ITEM 5(a)

Application Number: 19/02402/FUL

Description Full planning application for the erection of two storage and distribution units (use class B8), with associated access, car parking, servicing, landscaping, earthworks, on and off-site drainage and off-site highway works.

At Land at Caldecote Farm, East of The M1 Motorway, Adjacent To Willen Road

PROPOSED MASTERPLAN

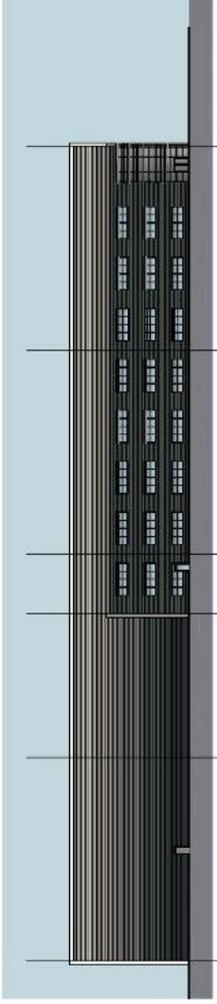
However, it is noted that a change in the location of the access to the car park serving unit 1 has taken place since the 18/01719/FUL proposals. The car park access is now located close to the main junction with Willen Road which could lead to vehicles waiting to turn right into the car park queuing back into the junction.

The proposed access to the car park for Unit 1 is located such that queuing on the main site access and into the junction with Willen Road could occur. This would seriously prejudice the operation and therefore the safety of that junction. As a result the proposals are contrary to Policy CT2 of Plan:MK.

Further to the Highway Observations dated 14th October 2019, the applicant has submitted a revised access plan for Unit 1 which overcomes the previous highway objection.

LAND AT CALDECOTE FARM NEWPORT PAGNELL		 www.php-architects.com	PROJECT NO: 4179 - SK017 DATE: JUL 2018 SCALE: 1:360	REV: DRAWING NO: SK017
SEGRO NEWPORT PAGNELL LTD				
UNIT 2 ELEVATIONS DRAWING NO: 4179 - SK017 DATE: JUL 2018 SCALE: 1:360		REV: DRAWING NO: SK017

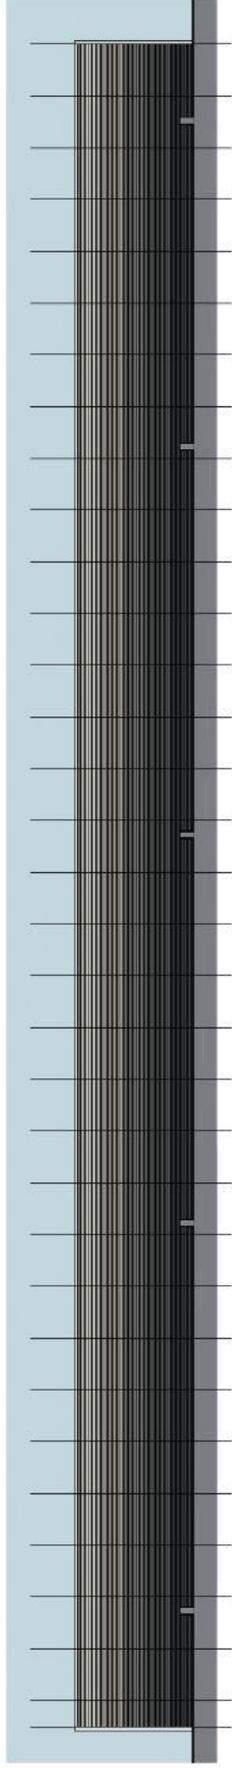
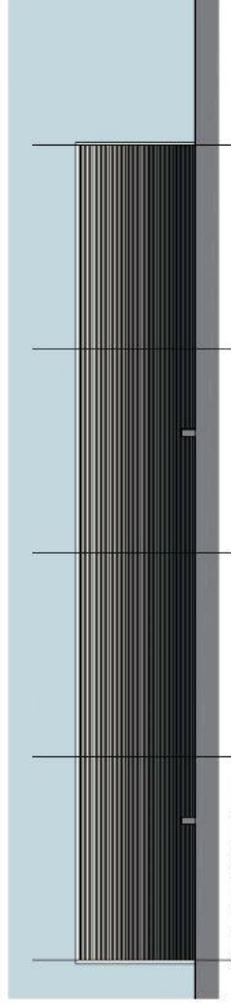
example, no street scene or context elevations have been provided, and no views from Willen Road which would provide more information on the impact on the character of these areas. This is especially important at this stage, as, were this development to be permitted, it would likely be constructed ahead of the rest of the MKE SUE, and would therefore stand in isolation, possibly for some time, before the rest of the MKS SUE was built around it.

3. There are existing dwellings to the east of the application site at risk of a significant detrimental impact on residential amenity as a result of visual impact and overbearing nature of the development. The height and position of the proposed buildings, the lack of landscaping and the lack of set-back between the buildings and Willen Road will contribute to an unacceptable impact on the residential amenity of the existing residents. In the absence of supporting information to show otherwise, it is considered that the proposal is therefore contrary to Policy D5 (A.5.) and Policy D3, in Plan:MK (2019).
